Access Compliance Report

Public Rights-of-Way

(Curb Ramps)

Intersection ID: 31460	Main Street: BOMAR_DR	Cross Street: HAMILTON_OAKS_DR	Location: NW
ADA ID: E6C85BFCDAAA	Ramp Type: PerpDiag	Initial Pass/Fail: Pass	Overall Compliance: No
Severity Score: 25			
Codes/Mitigation Info/Possible Solution		Field Measurements/Component Compliance

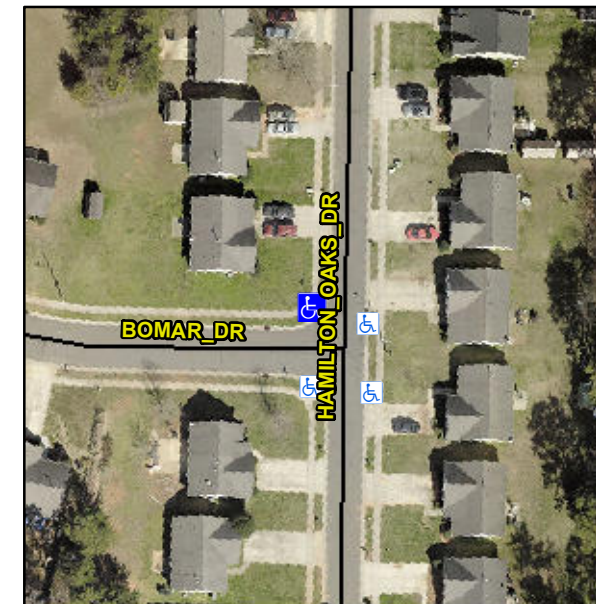
Not Found, R304.2.1, R304.2.2-Perp, R304.3.2-Para, R304.5.3, R305, R304.5.4

Compliance	Description	Data	Compliance	Description	Data
N/A	Ramp Length (in)	99.5	Yes	Ramp Slope (%)	7.5
Yes	Ramp Width (in)	48.0	Yes	Ramp XSlope (%)	0.5
N/A	Flare Type LT	None	N/A	Flare Type RT	N/A
N/A	Flare Slope LT (%)	N/A	N/A	Flare Slope RT (%)	N/A
N/A	Flare Traversable LT?	N/A	N/A	Flare Traversable RT?	N/A
No	Landing Length (in)	N/A	No	DWS Provided?	No
No	Landing Width (in)	N/A	N/A	DWS Contrast?	No
No	Landing Slope (%)	N/A	N/A	DWS Length (in)	N/A
No	Landing X Slope (%)	N/A	N/A	DWS Full Width?	No
N/A	Landing Curb? (Y/N)	No	N/A	DWS Offset (in)	N/A
N/A	Shared Landing?	No			
Yes	Gutter Ponding?	No	No	Gutter Slope (%)	11.2
Yes	Gutter Lip Ht (in)	0.0	Yes	Gutter X Slope (%)	0.7
N/A	Painted X Walk1?	No	N/A	Painted X Walk2?	No
	X Walk 1 Direction	To SW		X Walk 2 Direction	To NE
N/A	X Walk 1 Width (in)	N/A	N/A	X Walk 2 Width (in)	N/A
	X Walk 1 Slope (%)	1.1		X Walk 2 Slope (%)	2.2
	X Walk 1 X Slope (%)	4.1		X Walk 2 X Slope (%)	1.1

N/A	Ramp inside XWalk1?	N/A	N/A	Ramp inside XWalk2?	N/A
	Road Slope (%)	0.9	N/A	Clear Space?	Yes
	Road X Slope (%)	4.9	N/A	Clear Space to XWalk (in)	N/A
Yes	Any Obstructions?	No	Yes	Storm Grate/Utility Hazard?	No
	Obstruction Type			Storm Grate/Utility Type	
		N/A			N/A
			Yes	Surface Condition? (G/P)	Good

Remove & Replace Curb Ramp With Two New Directional Ramps or Equivalent. Remove & Replace Gutter.
